Government of the District of Columbia
Advisory Neighborhood
Commission 6C

Re: ZC 18-16, 19-27, 19-27A, & 19-27B (Rulemaking)

Re: Zoning Administrator Interpretation of 11-E § 206 (Rooftop Elements)

Re: Defective Zoning Administrator Interpretation of 11-E § 206 (Rooftop Elements)

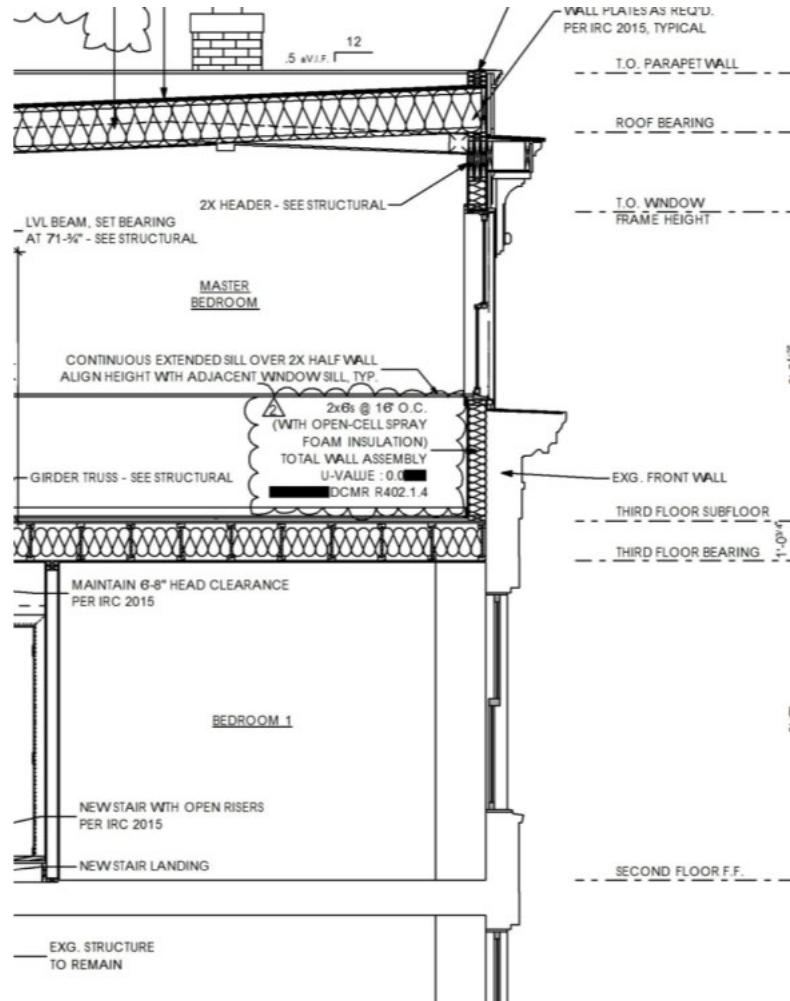
In his only published interpretation of section E-206, the ZA states that “the addition of a floor or penthouse—usually behind the element—must be set back at least three feet from the rooftop architectural element to preserve its architectural integrity.” ZA-007 (Oct. 1, 2019).²

In early March, however, I observed new construction in my SMD where the upper-story addition has zero setback:

I promptly wrote to the ZA, expressing my concern that this is not in keeping with section E-206. As shown in his response (copy attached), the ZA asserts that his setback rule does not apply to cornices. (No such distinction is suggested in the text of ZA-007.)

The ZA's position is deeply problematic for two reasons. The first, purely esthetic reason is that allowing such construction diminishes the visual impact of the original cornice. That is especially true where, as in the drawing above, a new cornice is proposed for the top of the addition.
